Appendix N – Public Consultation

Schedule "C" Class Environmental Assessment for Airport Road from Braydon Boulevard / Stonecrest Drive to Countryside Drive

N.2 – Public Information Centre #1 Summary Report

Summary of Public Information Centre #1

Exhibit 2-3: Attendees left comments indicating their support of the proposed improvements to Airport Road

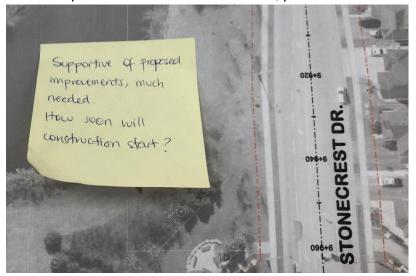
Residents and stakeholders present were supportive of the proposed improvements to Airport Road. Some attendees remarked on the need for improvements along this corridor and inquired about the potential construction start date, per the note shown in **Exhibit 2-3.**

- Consideration of intersection pedestrian signals (IPS) at Treeline Boulevard and Eagle
 Plains Drive to facilitate safe access for pedestrians and transit users.
- Review the location of the proposed multi-use path (MUP) at the plaza entranceway south of Countryside Drive to improve visibility and raising the MUP across the entranceway to reduce the speed of vehicles.
- Confirm that the proposed crosswalks do not overlap at intersection locations as they should terminate at the curb per AODA requirements.
- Revise the island on the north leg of the intersection at Airport Road and Countryside
 Drive as it is encroaching into the proposed cross-ride.

Based on the input received during the PIC, the project team will confirm the study findings and further refine the preliminary preferred design ahead of filing of the Environmental Study Report.
